Modification 1 Application

Walla Walla Solar Farm

August 2021

Project Number: 21-200

Figure 1-2 Approved project layout

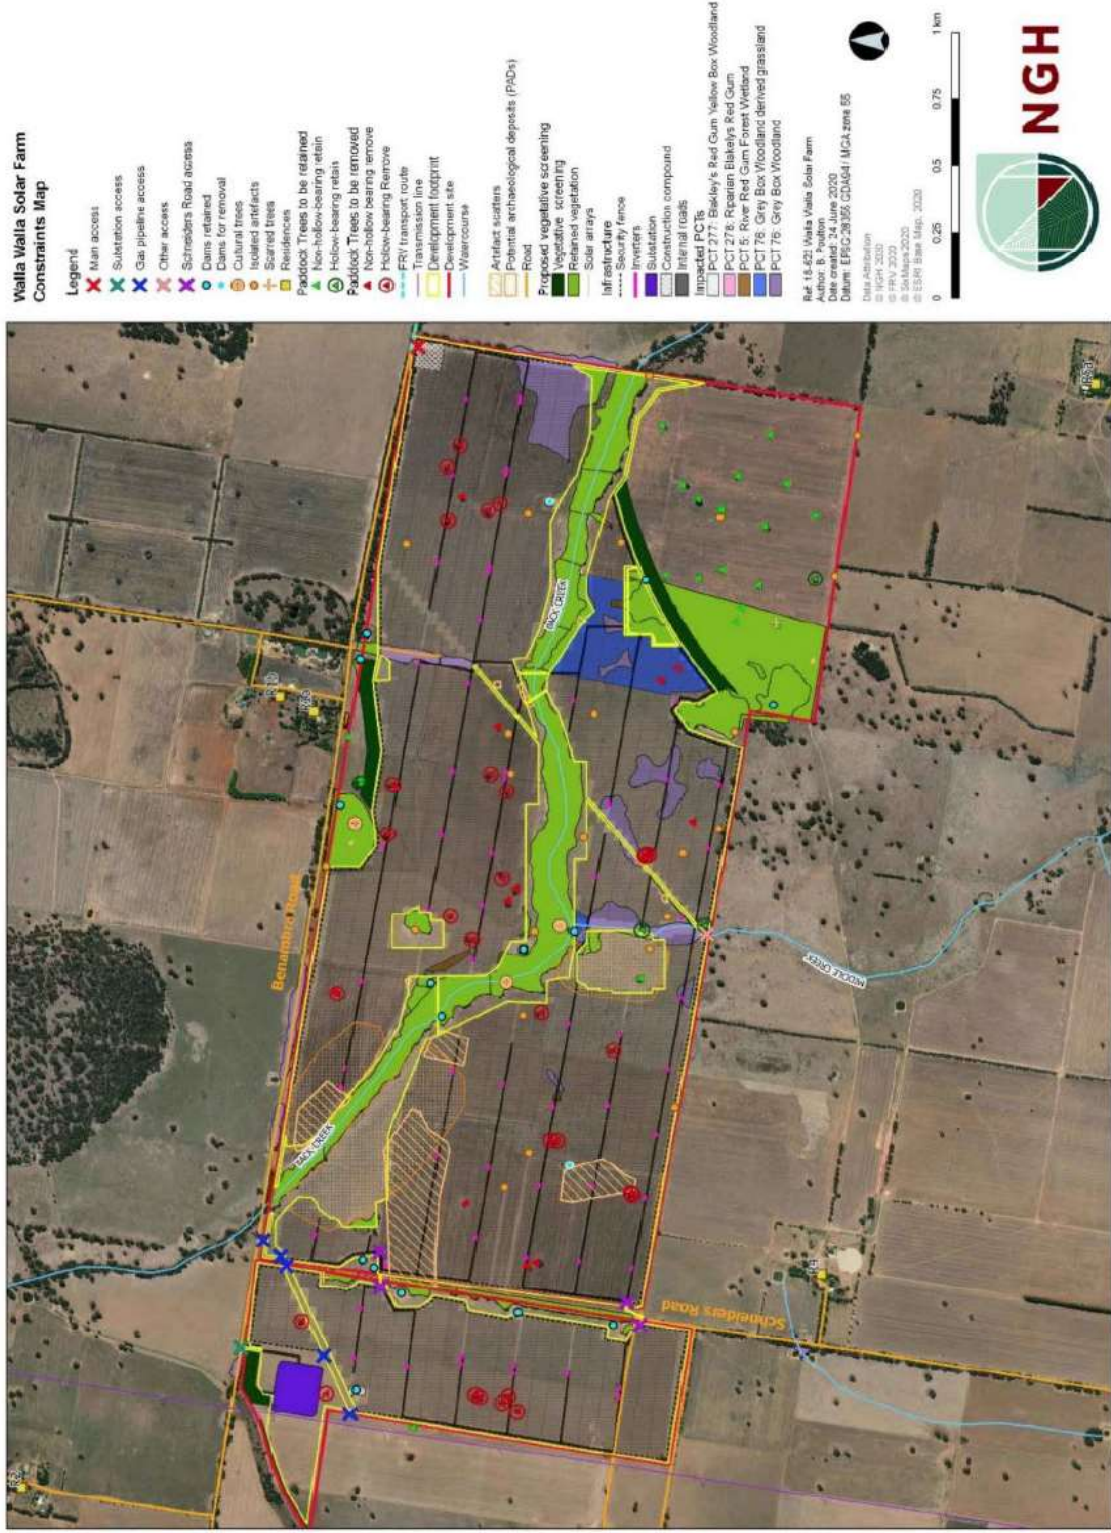
Whilst the proponent fully respects setback distances that were committed to during the EIS, it is apparent that this condition by the IPC contains an error in setback distances from the position of solar farm infrastructure that has already received development approval.

Whilst a distance of 930m separates R2 from the solar array, the approved site layout shows the substation a distance of 900m from R2.

The proponent seeks the Department's assistance in rectifying this miscalculation by either:

- Removing the word 'substation' from condition 5 of Schedule 2; or
- Reducing the required offset distance from 930m to 900m.

Figure 5-1 Walla Walla Substation transmission connections

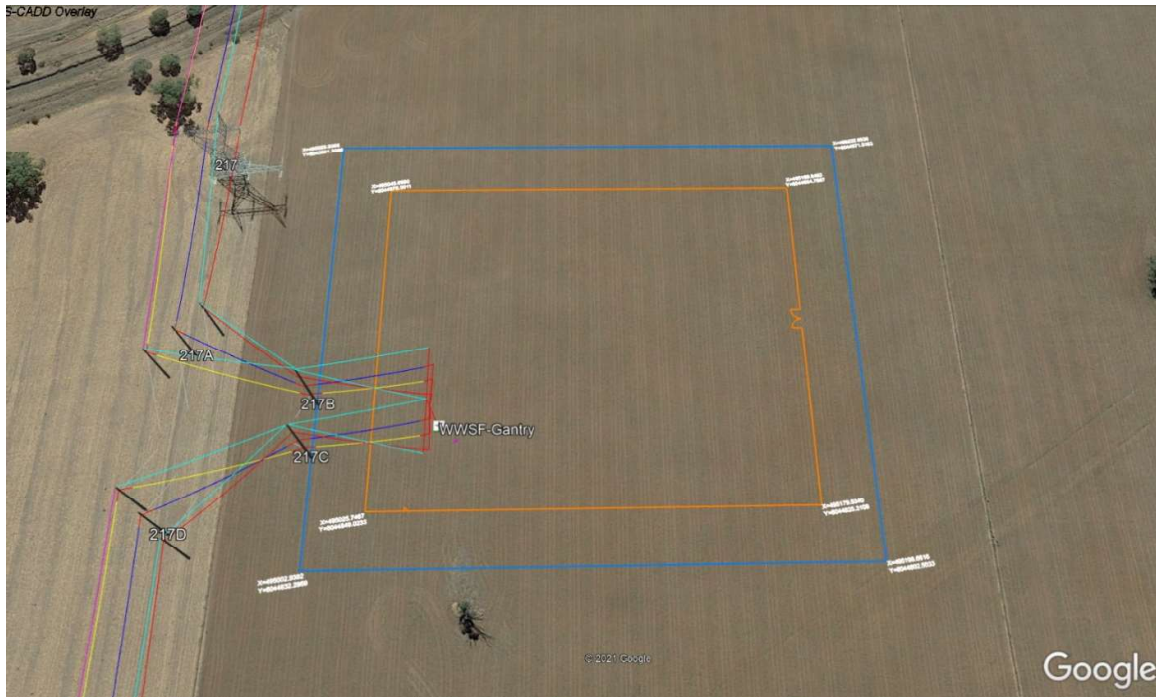
- Safe clearance distances of the transmission poles in accordance with Australian and TransGrid Standards. This requires six 30m poles (217A and 217D) and two 36m poles (217B and 217C) (Figure 5-1).

Additional design amendments by TransGrid have identified the need for taller transmission poles than described in the EIS. In order to allow safe clearance distances in accordance with Australian and TG Standards, six 30m poles (217A and 217D) and two 36m poles (217B and 217C) are proposed to be installed (refer Figure 5-1). It should be noted that these poles would be equivalent in size to the existing transmission infrastructure.

Figure 5-2 Profile of proposed solar array

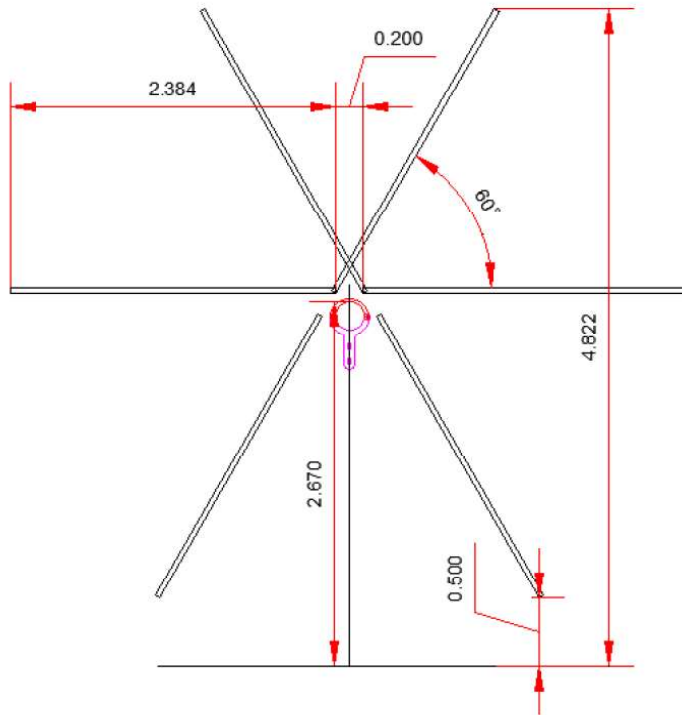
Project amendments during the final stages of the Department’s assessment placed strain on the development’s ability to produce its nameplate capacity, when offset distances for receiver R5a were increased from 800m to 1.8km. During detailed design, and as a result of improving technology, it was found that increasing the approved maximum height of solar panels to 4.85m would allow the project to improve efficiencies within the development site, ensuring the financial viability of the project. The new panels would not change the approved development footprint of 421ha, and previous commitments in relation to minimum setback distances from nearby receivers would be respected. However, depending upon the final panel configuration, the proposed spacing between panels may change to between 4.5m and 14m. The new panels would have a typical maximum height of 4.85m.

The modification would allow the use of newer, higher efficiency panels with a maximum height of 2400mm, arranged in a “two in portrait” orientation, as shown in Figure 5-2.

Whilst the modification proposes to increase panel height by 85cm, it should be noted that panels would only be at their full, extended height for a period of approximately 30 minutes per day. In addition, FRV's investment in an active backtracking system would limit the amount of time that panels spent above 4m in height to approximately 2 – 3 hours at sunrise and 1 – 3 hours at sunset.

Figure 5-3 Walla Walla Solar Farm proposed modified access point for all traffic during substation construction

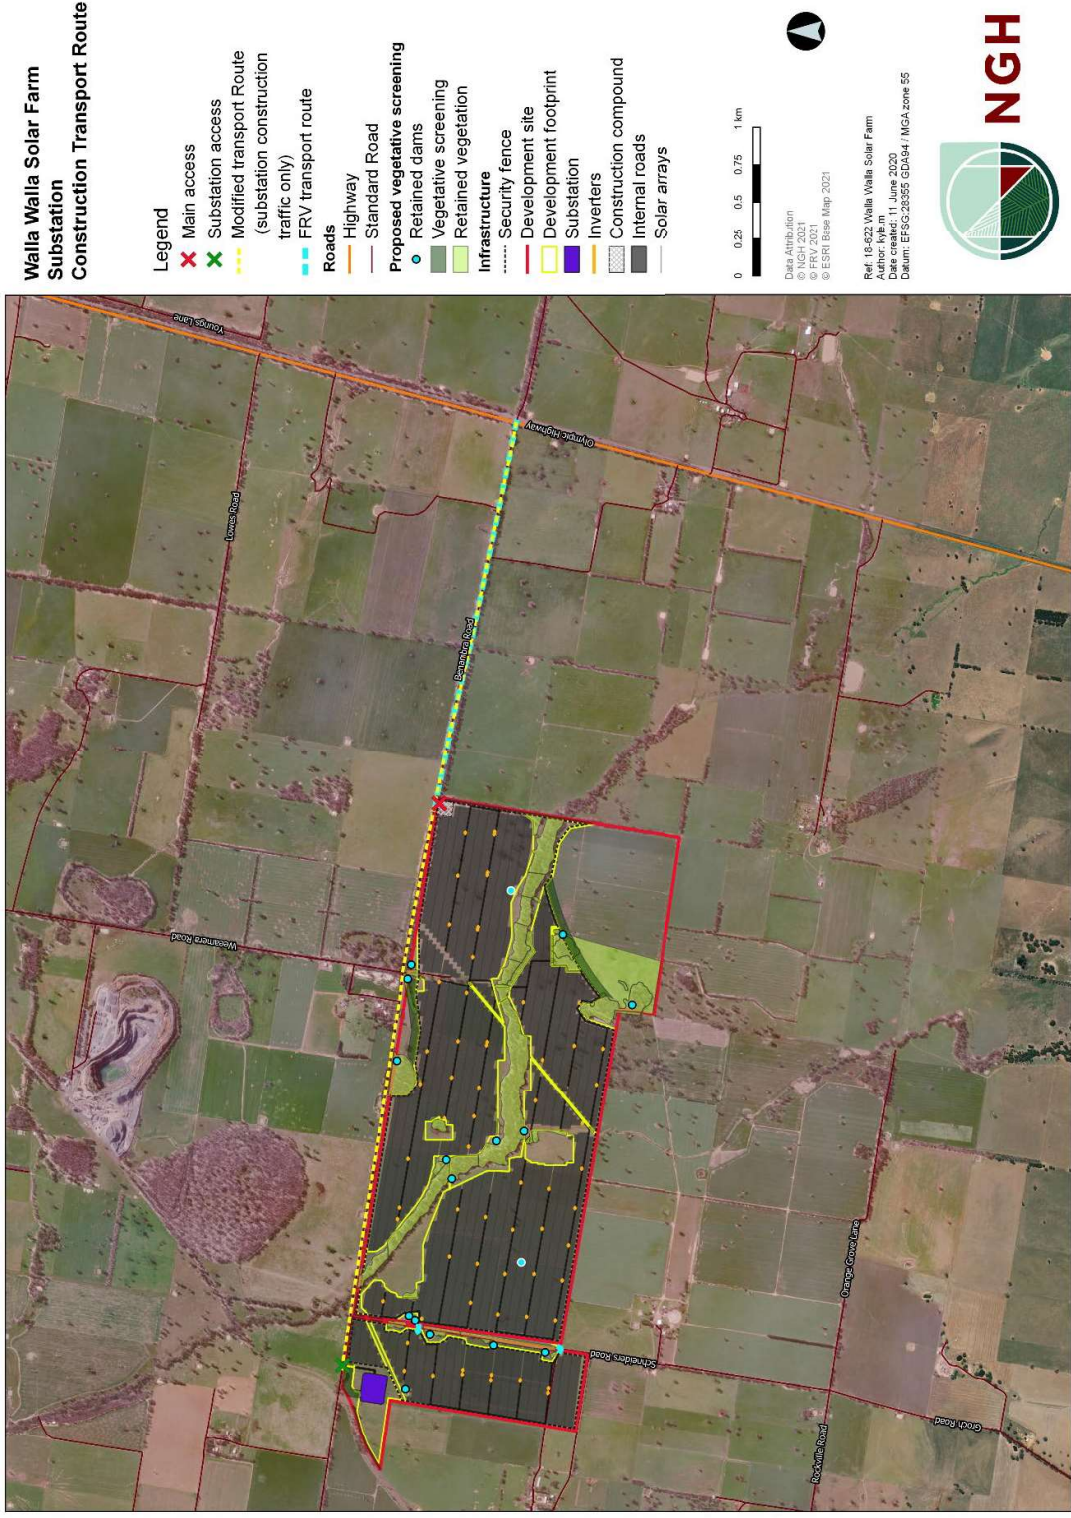
The Modification seeks to modify the approved transport route for light and heavy vehicles associated with construction of the Substation as shown in Figure 5-2. Over-dimensional construction vehicle access along Benambra Road to the operational substation access is already permitted by the project consent. It is proposed that all heavy vehicles associated with construction of the substation would access the site via the Olympic Highway and Benambra Road, and continue along Benambra Road to the operational Substation Access.

The main access point and internal access roads identified in the approved project would not be available for substation construction access, as internal roads would not yet be constructed at the planned commencement of construction of the substation.

It is estimated that construction of the substation would result in a maximum of 10 heavy vehicles per day using Benambra Road (west of Weeamera Road) and the dedicated substation site access. There would be no increase to the overall vehicle movements as outlined in the condition 2 of Schedule 3 of the development consent. Traffic impacts would predominantly occur early in the construction period, for a period of approximately six months during civil works, and decrease once civil works have concluded. The substation access would not be used for the construction of the remainder of the site. All other traffic would continue to use the primary access in the northeast corner of the site, use internal access roads and cross Schneiders Road to access the western portion of the site.
